APPLICATION NO.	FILING DATE	FIRST NAMED INVENTOR	ATTORNEY DOCKET NO.	CONFIRMATION NO.	
10/774,982	02/09/2004	Kurt J. Fredrickson	. KF-2004-01	9597	
7590 02/02/2007 Mark D. Kelly 5401 N. Shoreland Ave.			EXAM	EXAMINER	
			GABLER, PHI	GABLER, PHILIP FRANCIS	
Whitefish Bay, WI 53217-5132			ART UNIT .	PAPER NUMBER	
			3637		
SHORTENED STATUTOR	RY PERIOD OF RESPONSE	MAIL DATE	. DELIVER	DELIVERY MODE	
3 MO	NTHS	02/02/2007	PAI	PAPER .

Application No.	Applicant(s)		
	10/774,982	FREDRICKSON, KURT J.		
Office Action Summary	Examiner	Art Unit		
	Philip Gabler	3637		
The MAILING DATE of this communication app	oears on the cover sheet with the c	correspondence address		
A SHORTENED STATUTORY PERIOD FOR REPL WHICHEVER IS LONGER, FROM THE MAILING D  - Extensions of time may be available under the provisions of 37 CFR 1.1 after SIX (6) MONTHS from the mailing date of this communication.  - If NO period for reply is specified above, the maximum statutory period  - Failure to reply within the set or extended period for reply will, by statute Any reply received by the Office later than three months after the mailin earned patent term adjustment. See 37 CFR 1.704(b).	ATE OF THIS COMMUNICATION  (36(a)

West '682 Figures 1, 7, and 7A

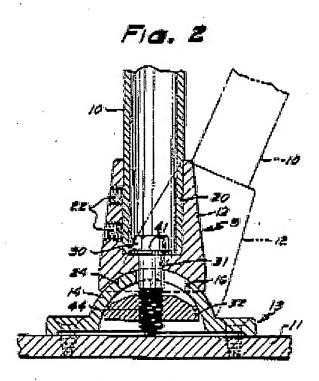
- 11. Regarding claim 10, Meyer discloses an apparatus as recited in claim 9, but does not disclose concrete or cement. West discloses a mounting apparatus with a concrete anchor (180) in which an attachment rod is embedded. Accordingly, it would have been obvious to one of ordinary skill in the art at the time the invention was made to allow Meyer's device to be secured by embedding the rod in concrete as taught by West because of the rigid mount and secure placement this arrangement would provide.
